Site Accessibility Evaluation

Costilla Parking Garage

Accessibility Evaluation

4th Floor Accessible Parking Stall/s

Finding 297287 Main Photo

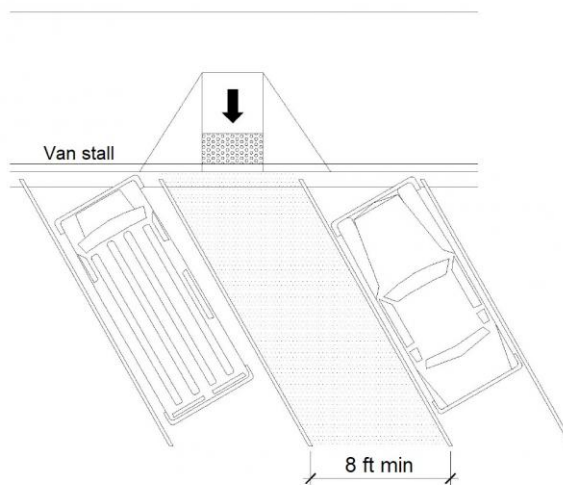
The access aisle is on the driver's side of the stall.

Access aisles must be located on the passenger side of the stall for angled van accessible stalls.

Access aisle on driver's side (angled parking stall)

Remove "van accessible" signage from 2nd stall. Van access aisles must be on passenger side for angled parking stalls.
